## **WILD WOOD BEACH SUBDIVISION**

APPLICATION NUMBER 9 DATE March 20, 2008

REQUEST Subdivision

## DETAIL SITE PLAN

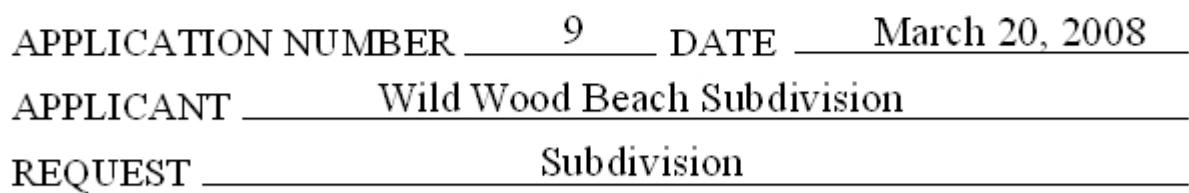
The purpose of this application is to create five lots of record from three metes and bounds parcels. However, there are several issues with this application. First, it appears that the proposed subdivision is including a portion of Parcel #R023904020006002. If so, this parcel should be included in the subdivision process in its entirety. Second, the proposed subdivision appears to contain more parcels than specified on the application, which will require additional postage and fees. Third, two of the subject parcels (R023904020003021.003 & R023904020006001) appear to have been created in 2004 without being properly subdivided; thus, the entirety of the parent parcels should also be included in the subdivision process. Finally, there appear to be discrepancies, with both the layout of the existing parcels and within the legal description.

The site is bounded to the East by Mobile Bay. To the West, the proposed subdivision fronts Dauphin Island Parkway, with 80' of right-of-way. Dauphin Island Parkway is not a major street at this location; thus, it exceeds the minimum right-of-way requirement. To the South, the proposed subdivision fronts Lawrence Steiner Road, a minor street with 50' of right-of-way. The Subdivision Regulations require minor streets without curb and gutter to have a minimum 60' of right-of-way. The plat should be revised to provide a minimum 30' from the center line of Lawrence Steiner Road.

The applicant is proposing a five-lot family subdivision, with all lots being flag lots with frontage on Lawrence Steiner Road. Lots 1 - 4 will each have approximately 45' of frontage, while Lot 5 will have 25' of frontage. As unusual shapes and depths of lots are typical near Mobile Bay, a waiver of Sections V.D.1. and V.D.3 of the Subdivision Regulations may be appropriate. However if approved, a note should be placed on the final plat stating that no future subdivisions will be allowed until additional adequate frontage on a public street is provided. Furthermore, as a means of access management, a note should be placed on the final plat stating that the entire site is limited to two curb cuts to Lawrence Steiner Road, which will be shared by

A common area, also flag shaped and containing an existing dirt driveway, is illustrated on the plat with 25' of frontage on Dauphin Island Parkway. If approved, a note should be placed on the final plat stating that the maintenance of all common area(s) is the responsibility of the property owners.

Three ingress, egress, and utility easements are illustrated on the plat. If approved, a note should be placed on the final plat stating that no construction will be allowed within these easements.

The lots appear to meet the minimum size requirement for developments with individual wells and septic tanks (40,000 square feet per state code). However, if approved, it is requested that the applicant revise the preliminary plat to label the lots with their sizes in square feet, or provide a table on the plat with the same information.

Furthermore, the minimum building setback lines, along street frontages, are not illustrated on the plat. If approved, the plat should be revised to depict 25' minimum building setback lines from Dauphin Island Parkway and Lawrence Steiner Road. Since the subdivision consists of flag lots, the setback lines should be from where the "poles" meet the "flag" portions of each lot.

Based on the preceding, it is recommended that this application be held over to allow the applicant to submit the following:

- 1) revised plat and legal description to accurately illustrate the subject area;
- 2) revised plat to account for all parcels involved in the subdivision process, including the entirety of parcels R023904020003021.003 & R023904020006001; and
- 3) any necessary additional postage and fees.
